PLAN COMMISSION MEETING AGENDA

**VILLAGE OF SISTER BAY
PLAN COMMISSION MEETING MINUTES
TUESDAY, FEBRUARY 24, 2026
UNAPPROVED**

a. Standard Zoning Permit Application; Review/Approve Modifications To Existing Tower; 2530 S Bay Shore Drive

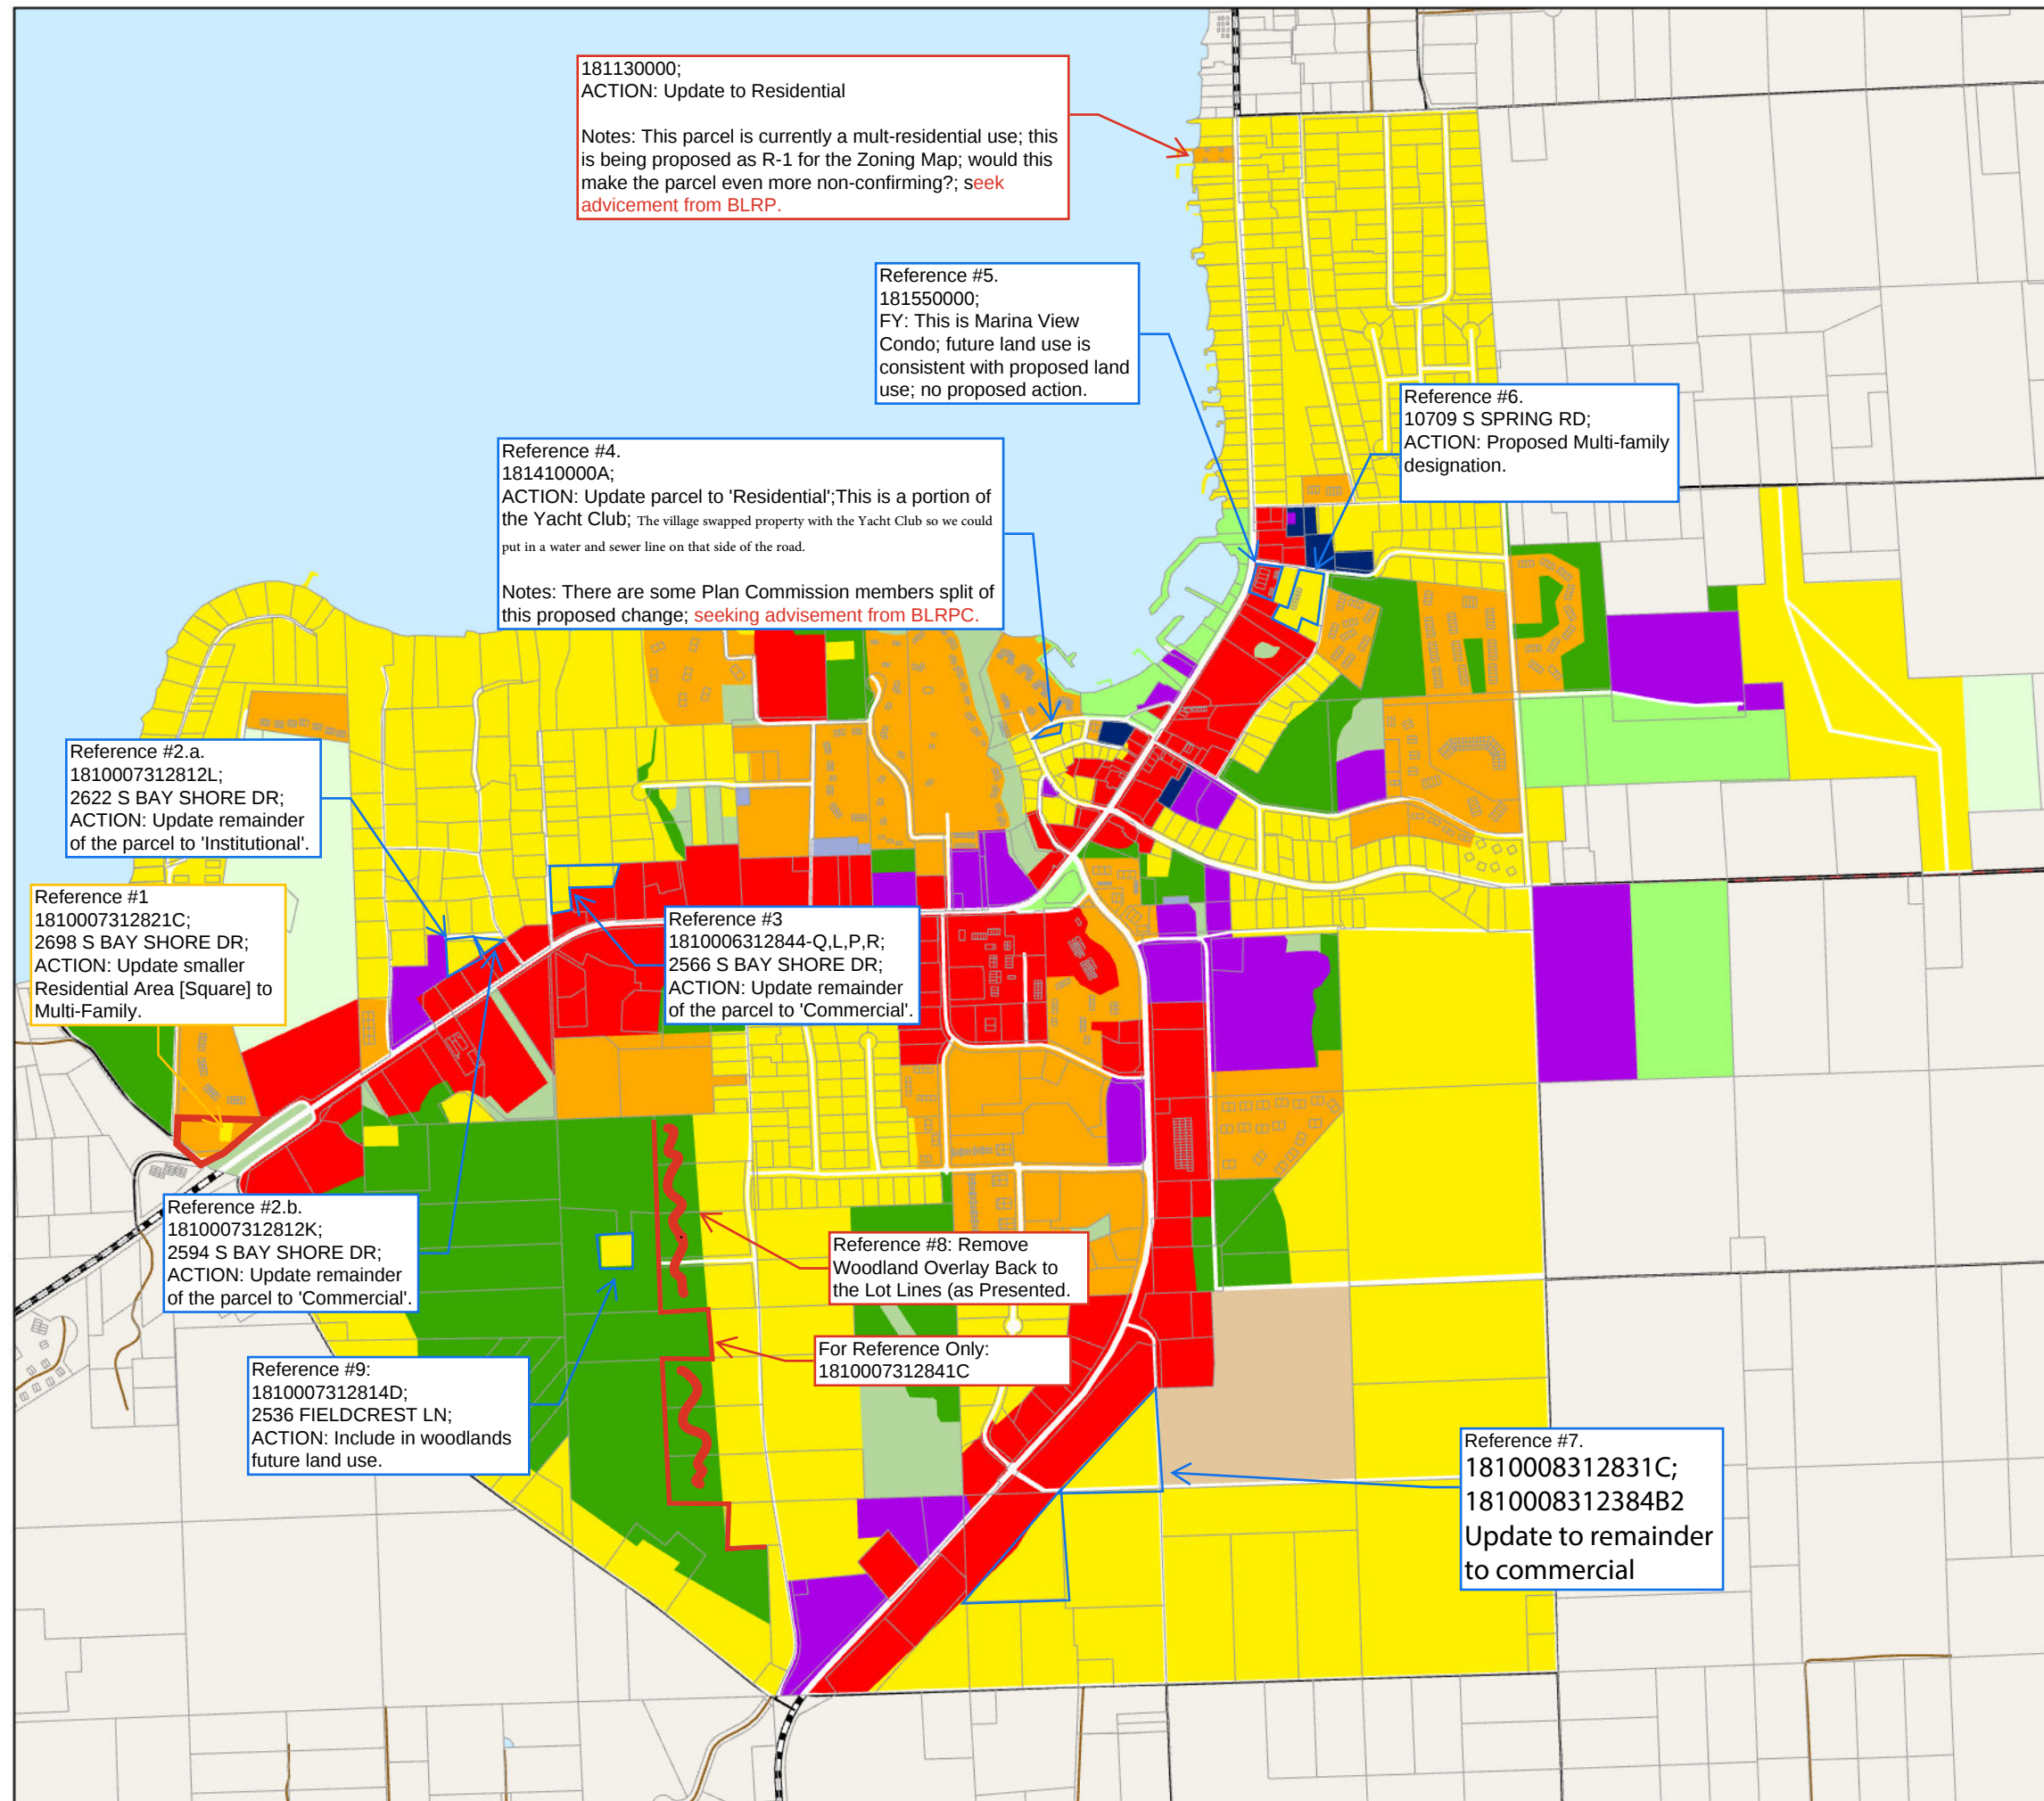
- 181130000, Rainbow Condominiums, N Bayshore Drive. Regarding this lot on the future land use map, it would make sense to mark the parcel as residential to correspond to neighboring uses. Residential as a future land use category typically illustrates single-family development, with the understanding that there may be exceptions as appropriate. Those exceptions are then regulated by the zoning map, which might show the parcel as some kind of residential use. Regarding the zoning of the parcel, there may be a conditional use allowing it to be a non-conforming R-1 parcel.

Please let me know how you would like to proceed with marking these properties on their respective maps. I will provide an updated draft once I know how they should be depicted.

Proposed Cooler and removal of cedar screening

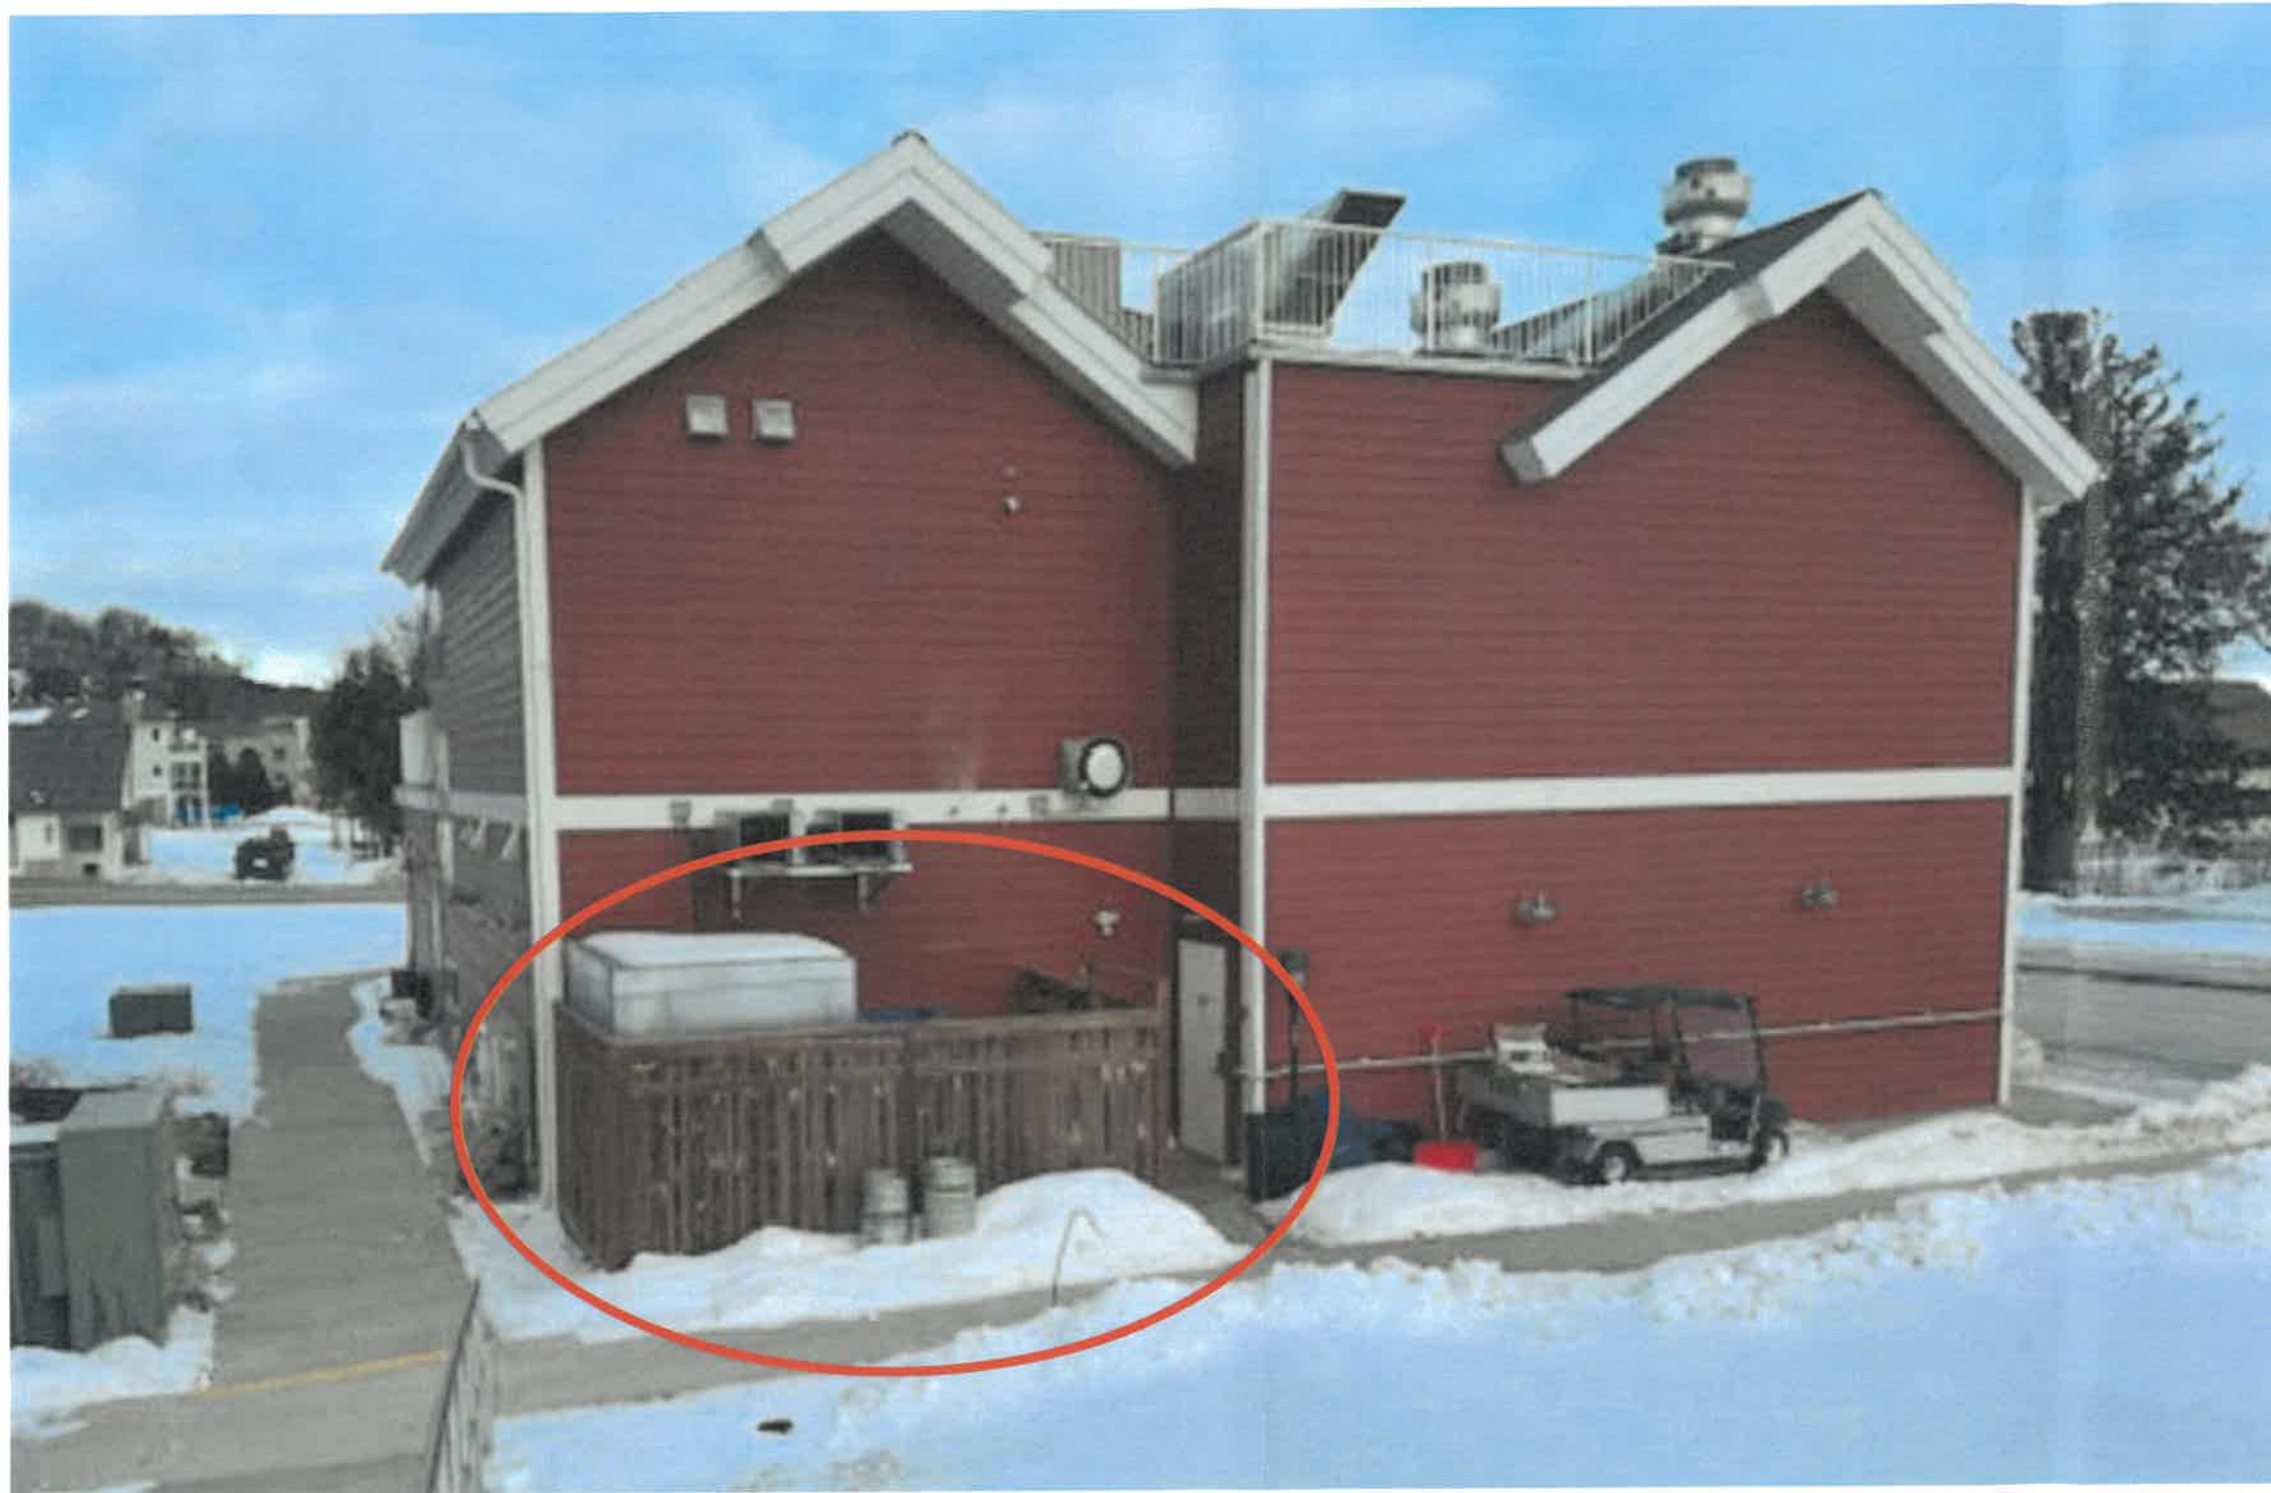
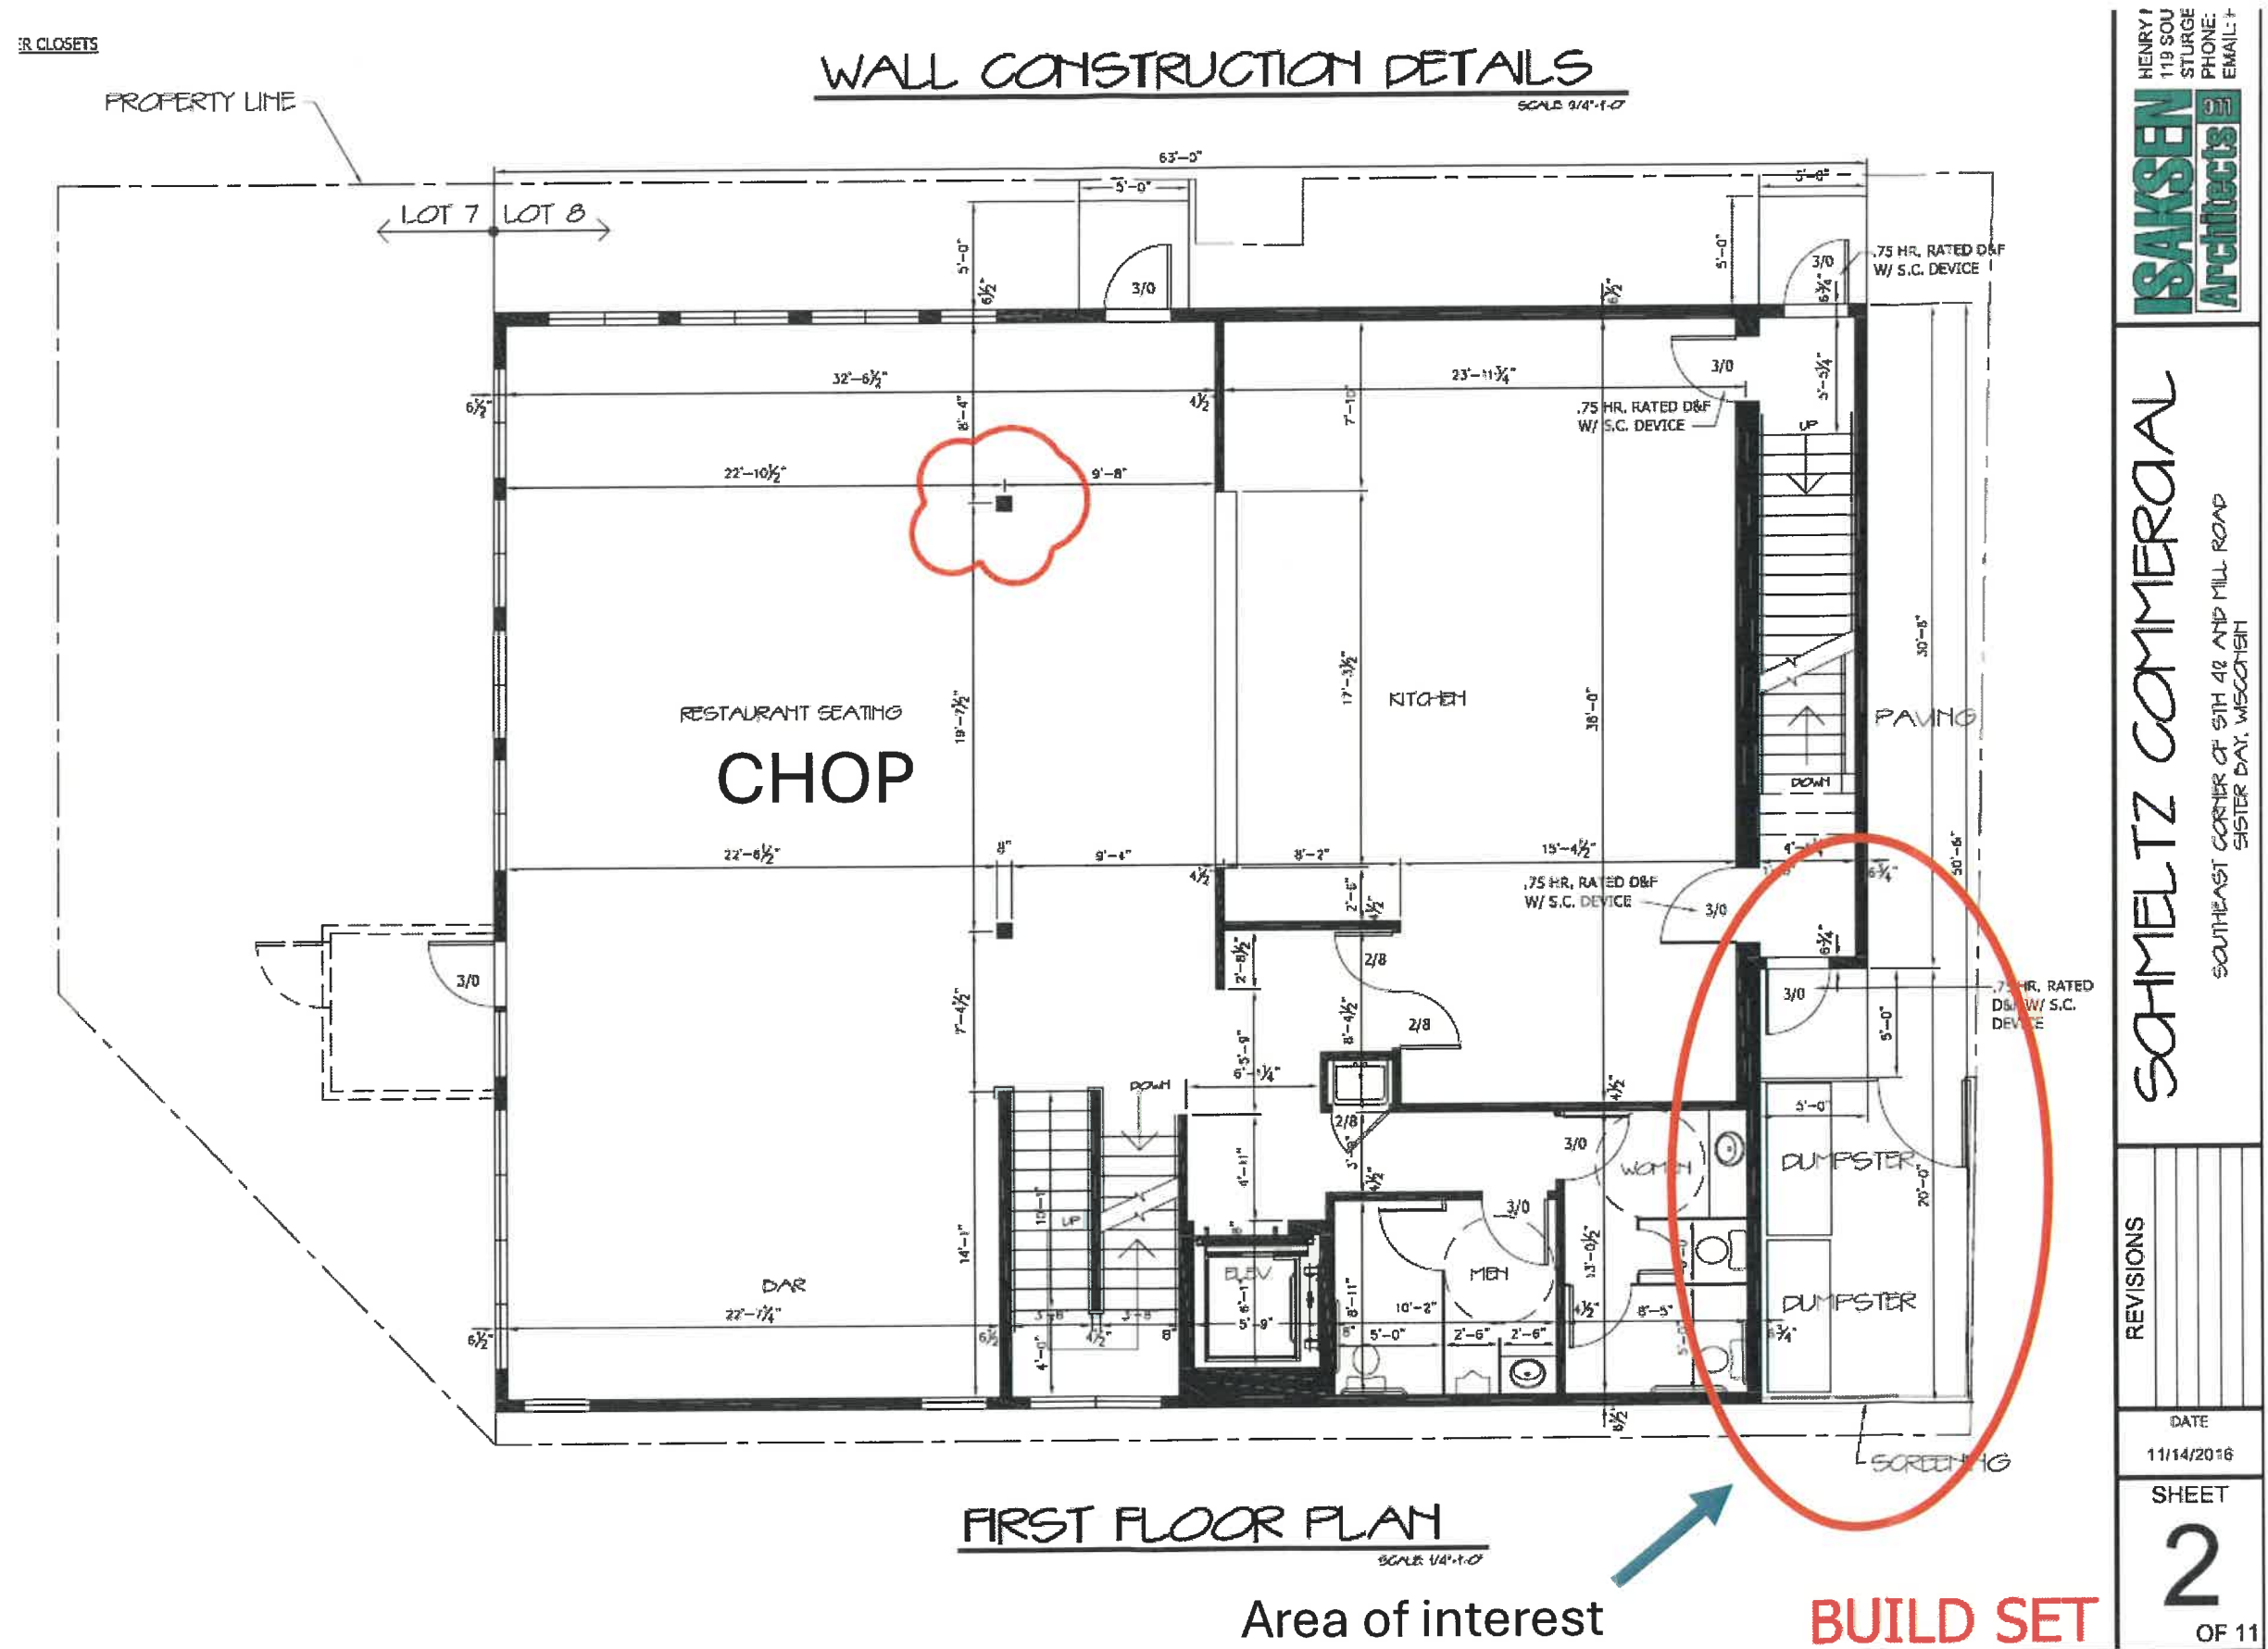
The applicant, Jaco Management (Mr. Chris Schmeltz), proposes to remove the existing 6-foot cedar screening fence behind CHOP Restaurant and to install a new outdoor cooler at the rear of the principal building. Per the applicant's statement, the cooler will be positioned against the building but not attached. The request is before the Plan Commission because exterior modifications require Site Plan and Architectural Review under Sec. 66.1050.

The existing 6' cedar fence currently provides screening. Removing this fence without providing an alternative screening solution would violate the screening requirements under these sections. The applicant is proposing the structure will be the same color as the primary structure and will be screened with a trellis with landscaping as show in the application materials.

Exterior modifications—including installation of an accessory structure and removal of screening—require Plan Commission review. The applicant has identified the cooler's location, proposed dimensions, and the proposed screening plan (including landscaping). Screening materials for mechanical equipment must match the primary building. The zoning code does not specify exactly which material (e.g., cedar, metal, composite), but it does require that the material be compatible with and match the building's exterior.
